**Re: *Response to Comments for Site Plan Approval - 218 Stone Street
and 123 Massey Street South***

Bergmann Associates, on behalf of the applicant COR Arsenal Street Company, LLC, (COR) is submitting the following material and written responses to a Memorandum prepared by Michael Lumbis dated June 2, 2016 with respect to the Site Plan Approval - 218 Stone Street and 123 Massey Street South.

C110

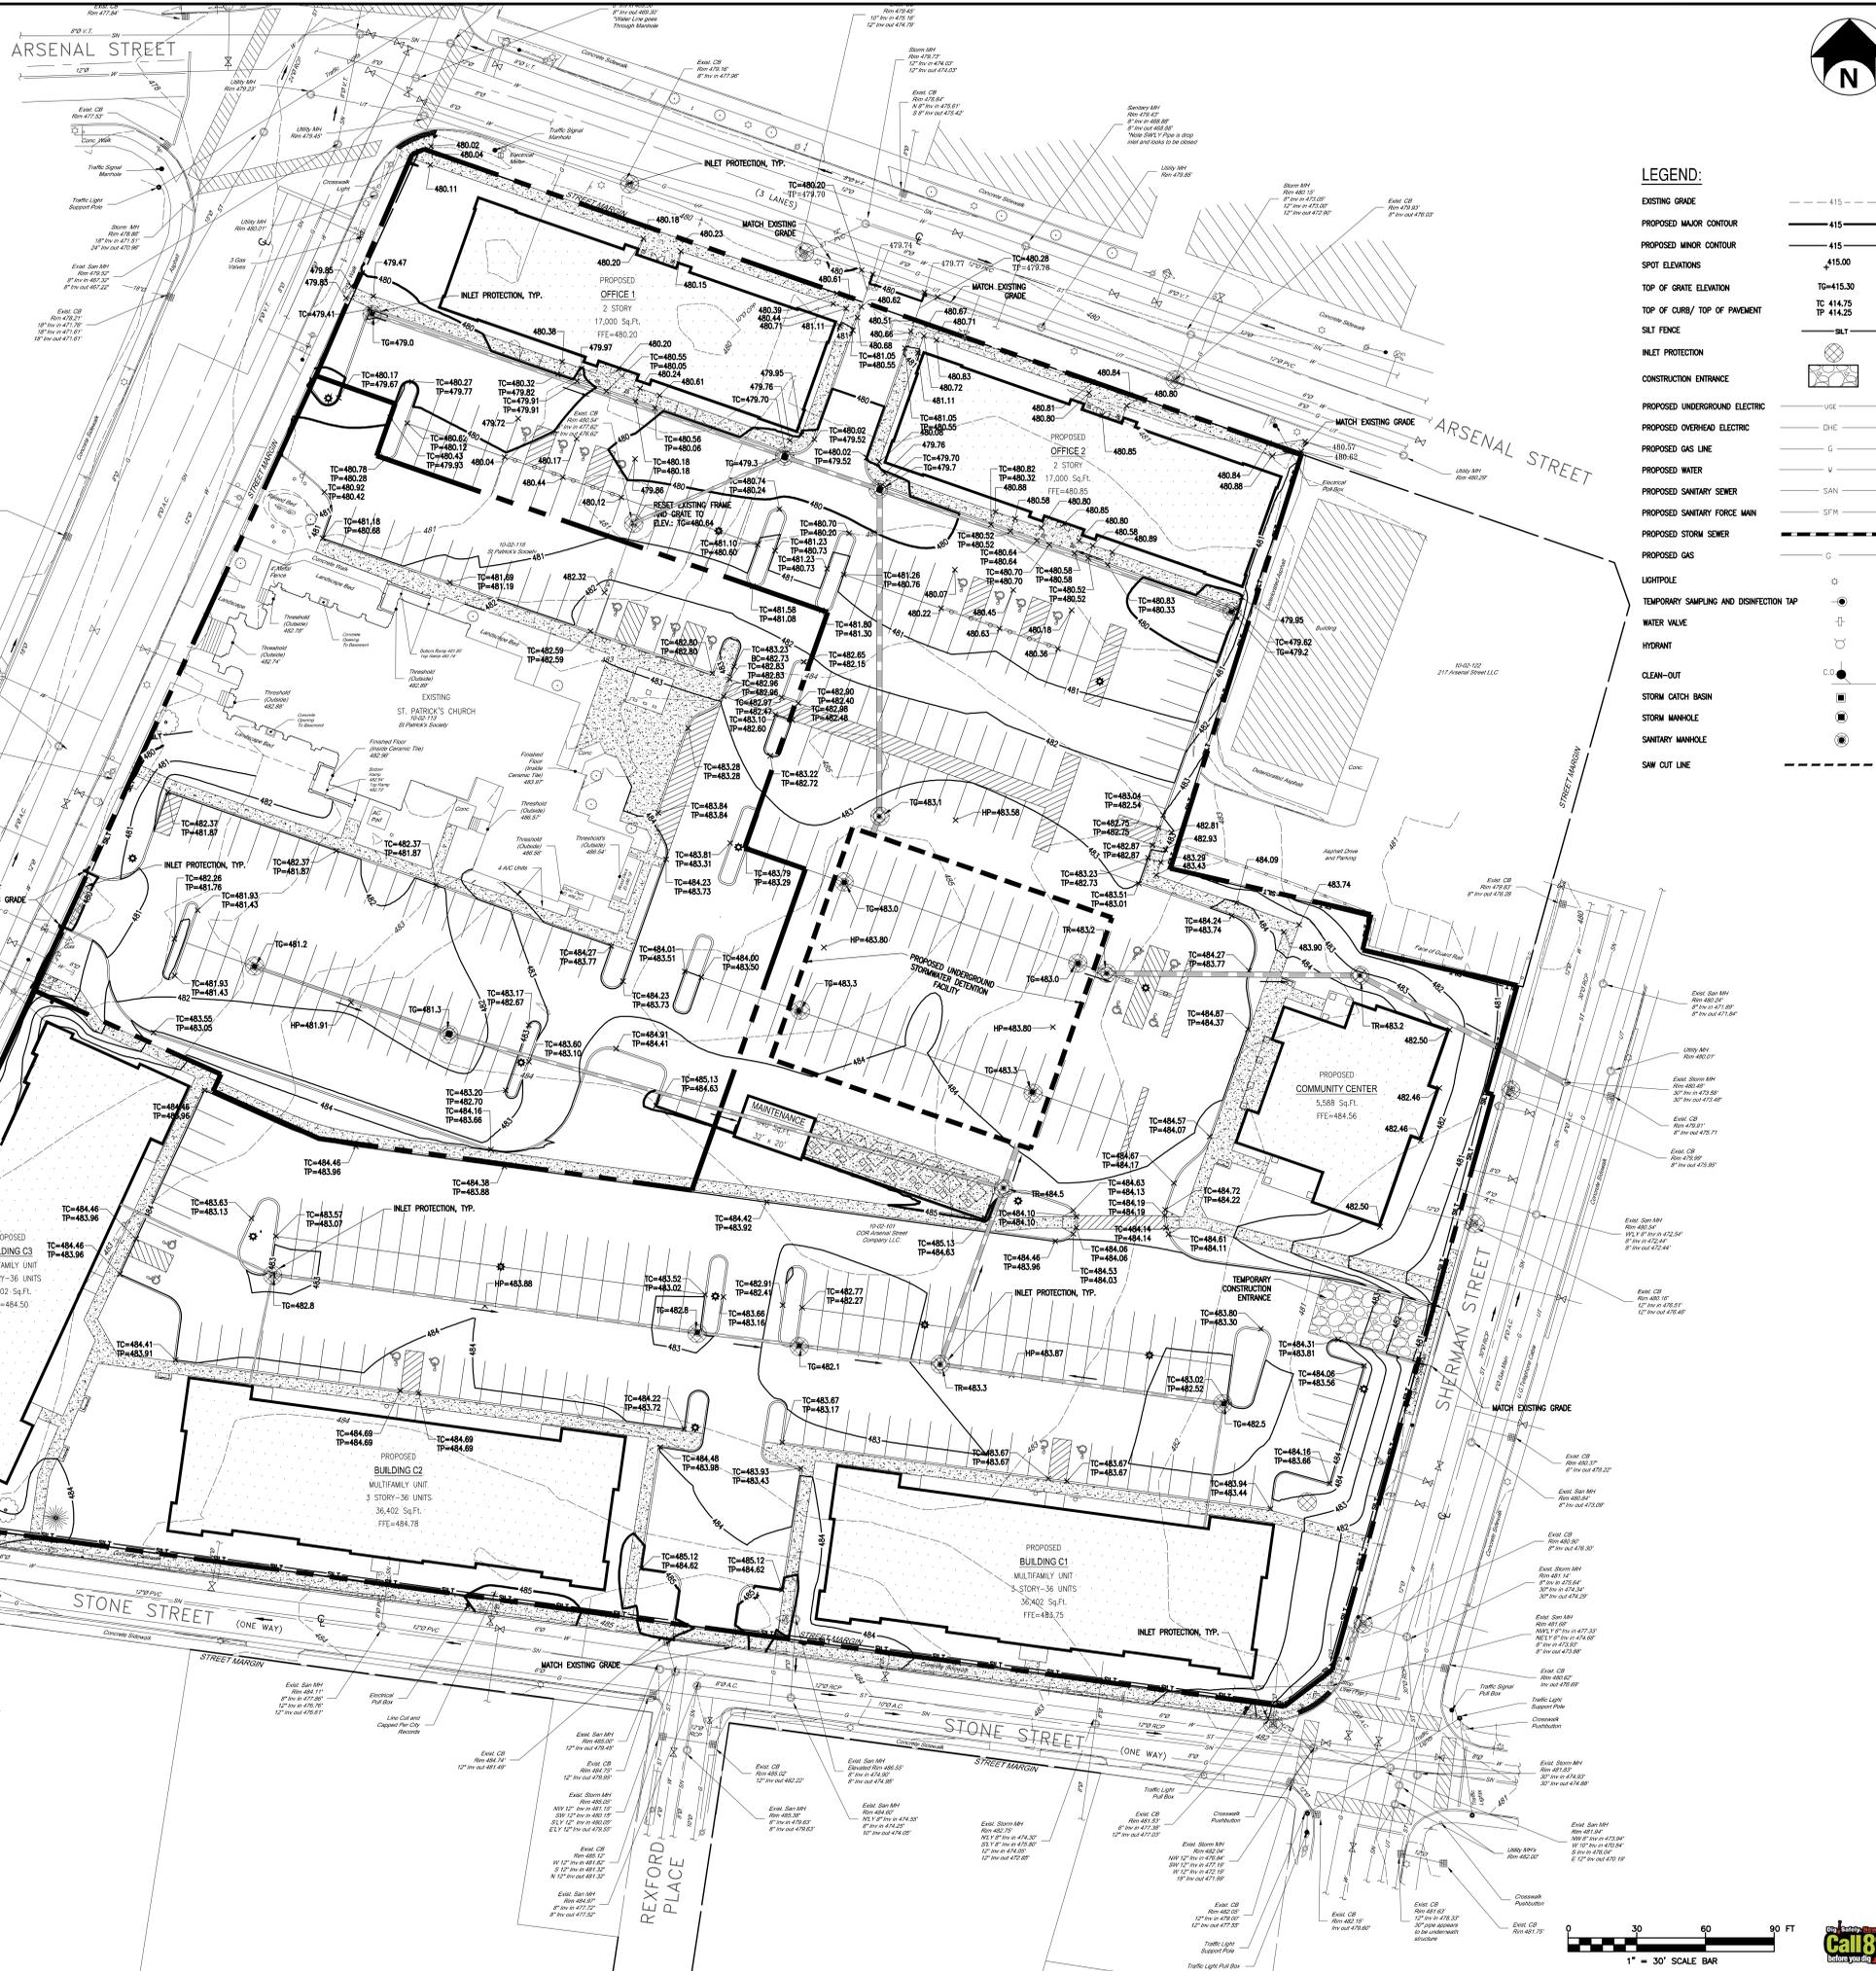
6. The applicant should add a note to the plans stating that existing laterals that are to be abandoned shall be capped and anchored.
Response: Utility Note #15 on sheet C110 has been added to indicate laterals to be abandoned shall be capped and anchored.

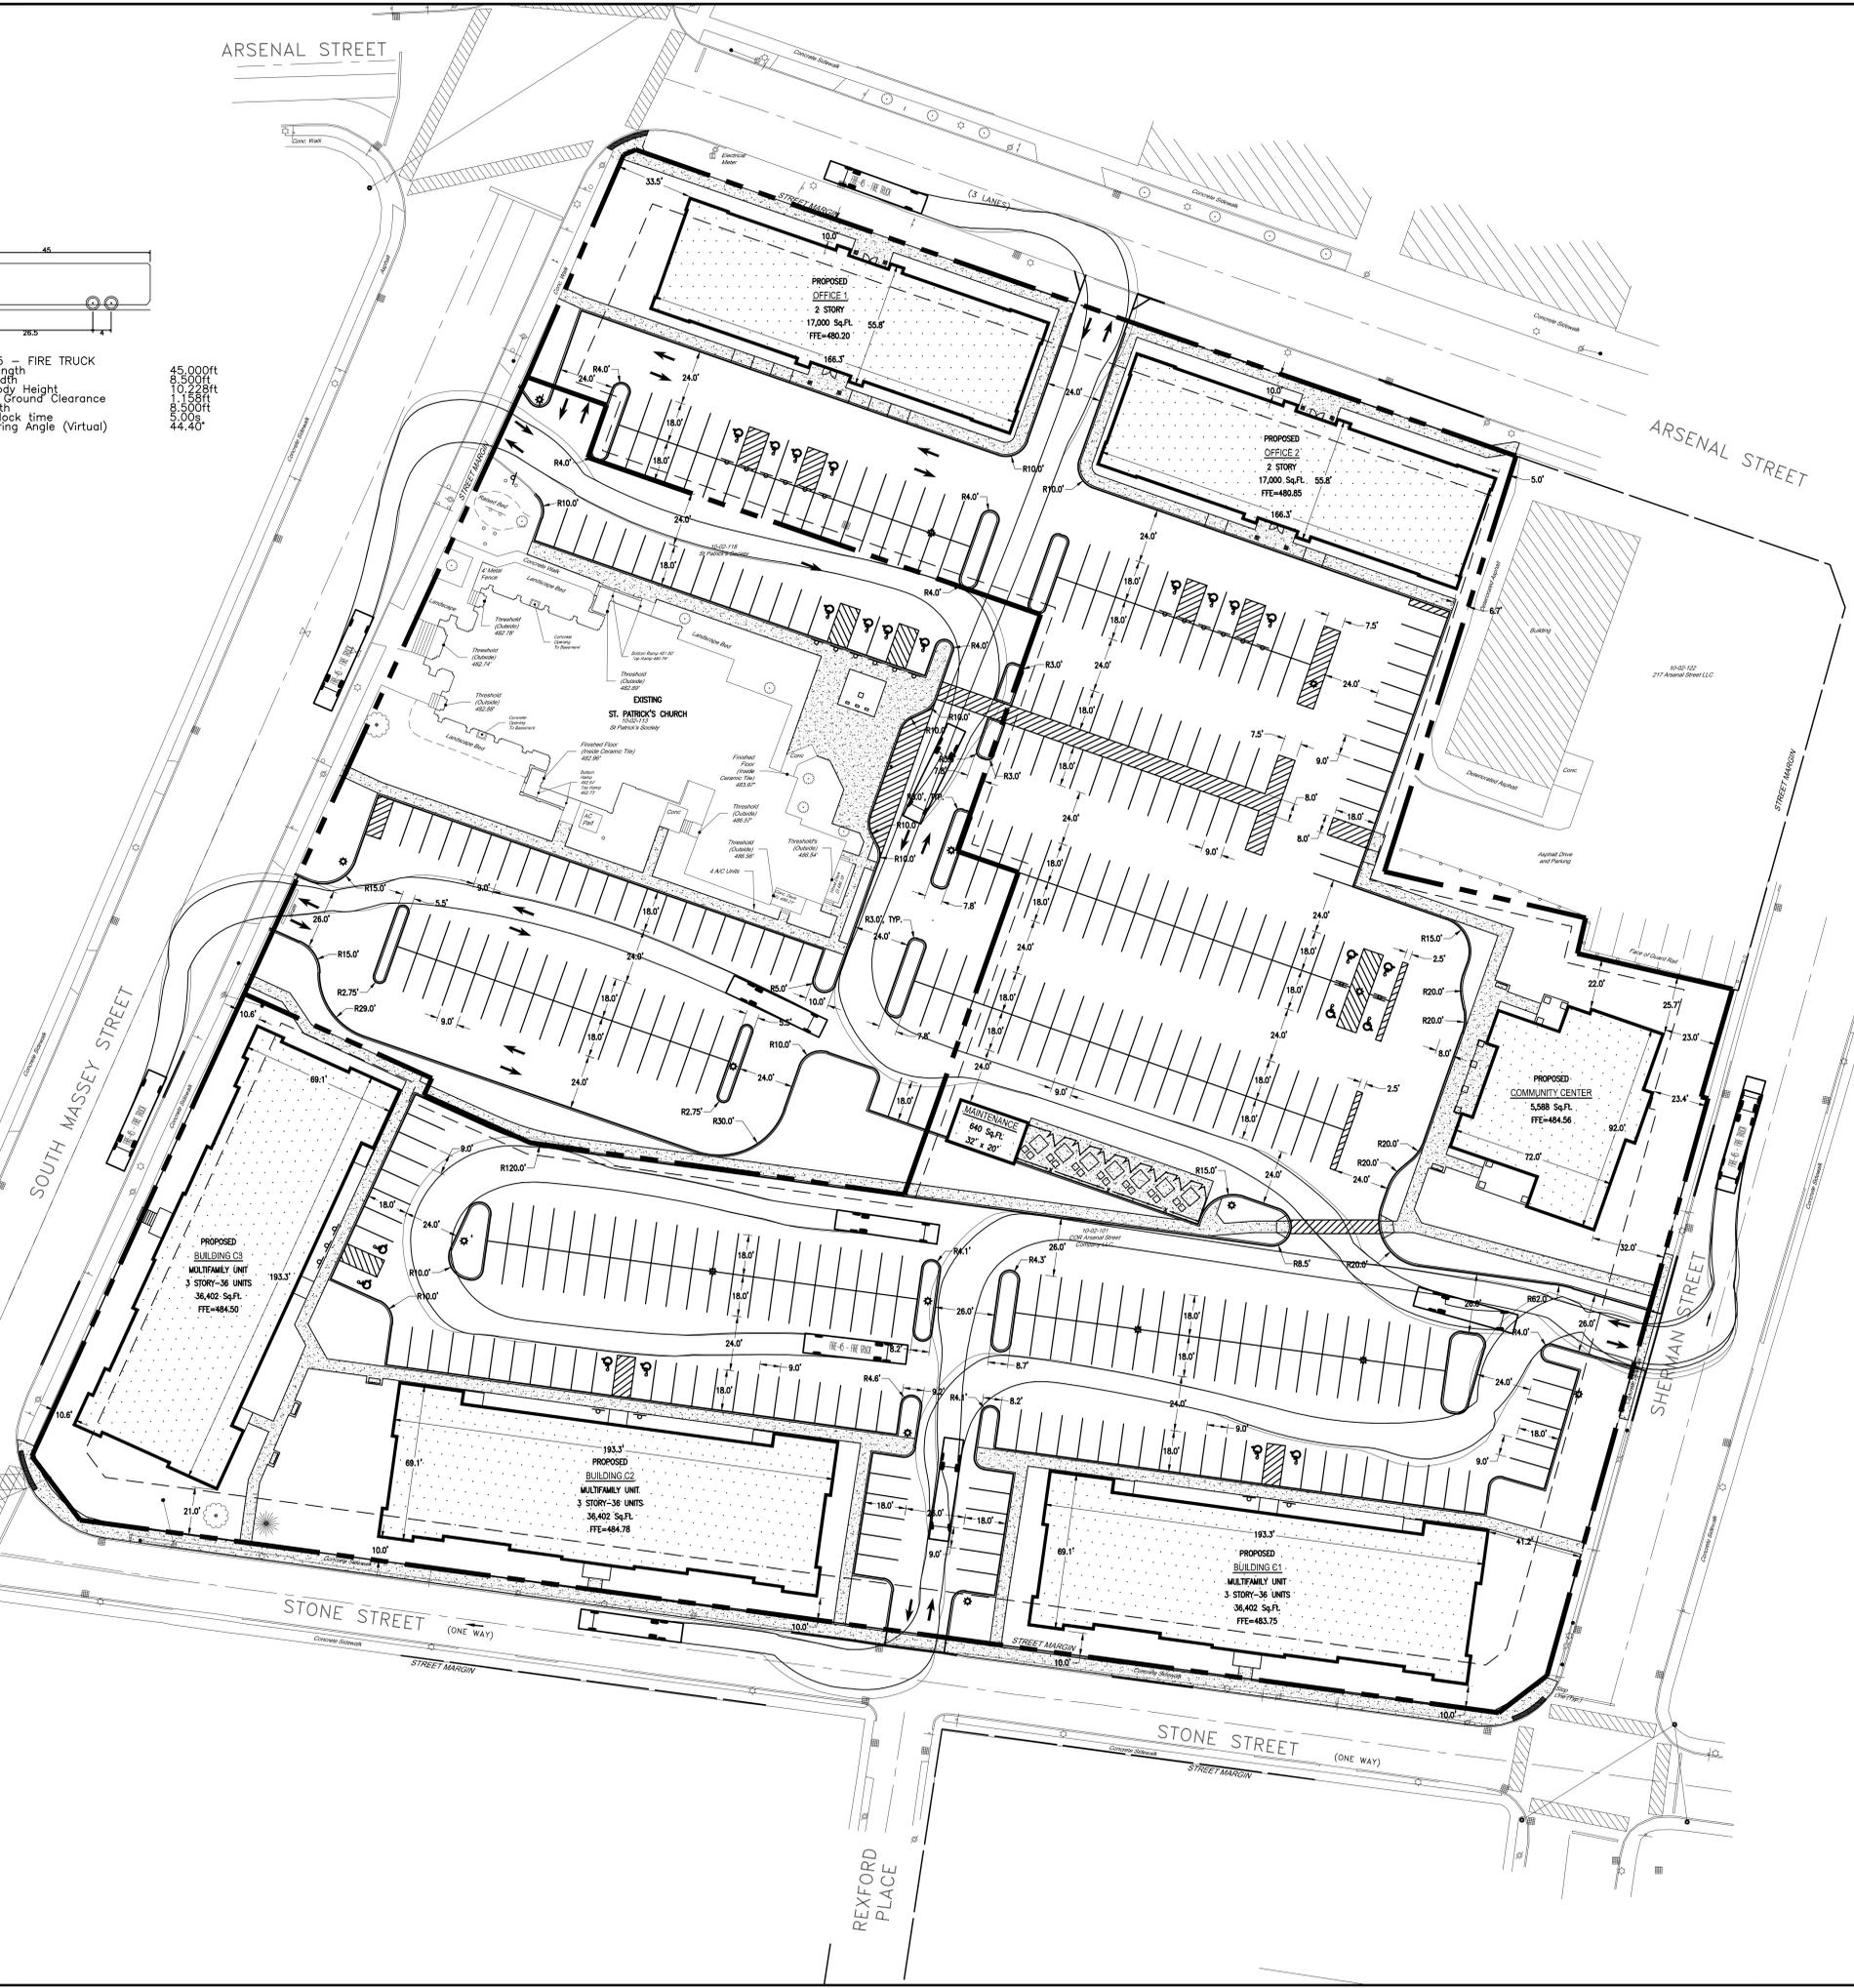
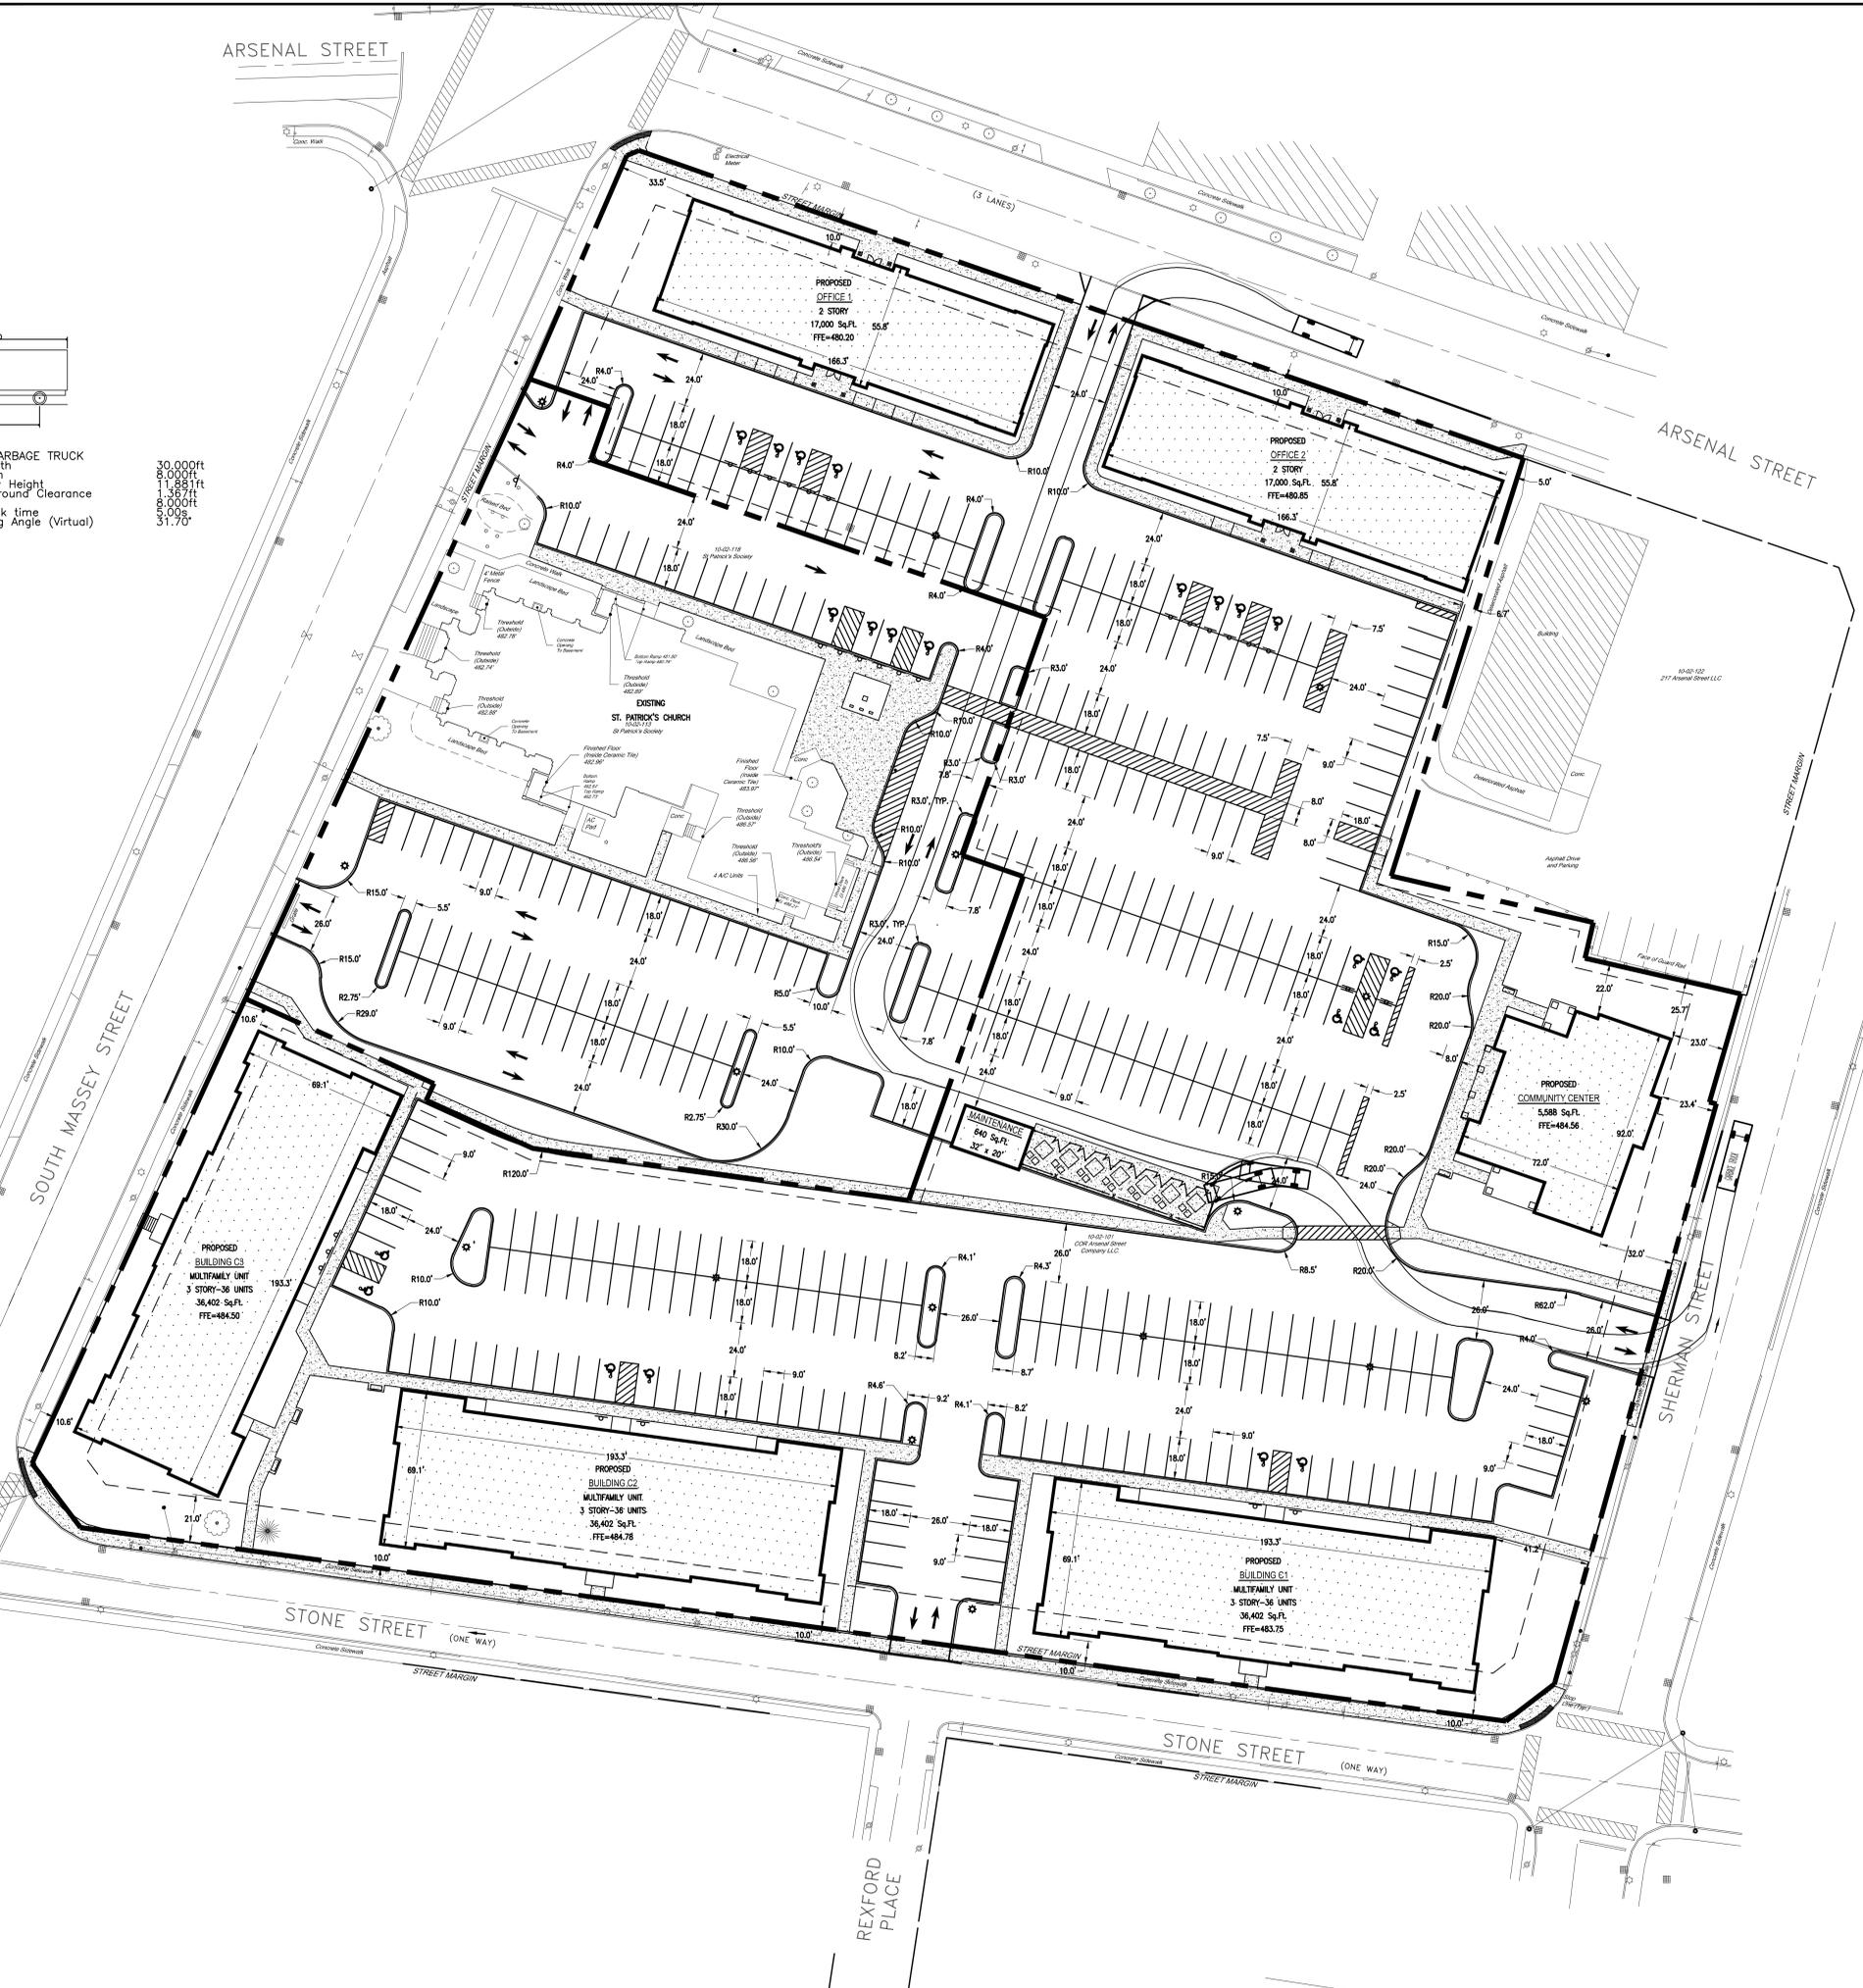
6. The applicant shall provide a Vehicle and Pedestrian Circulation Plan that shows the movements of a delivery or refuse vehicle as well as a City fire truck.

Response: Drawings FP-1 and GP-1 have been provided in the plan set for review.
7. The applicant shall add traffic arrows to each existing and proposed driveway to indicate traffic flow.
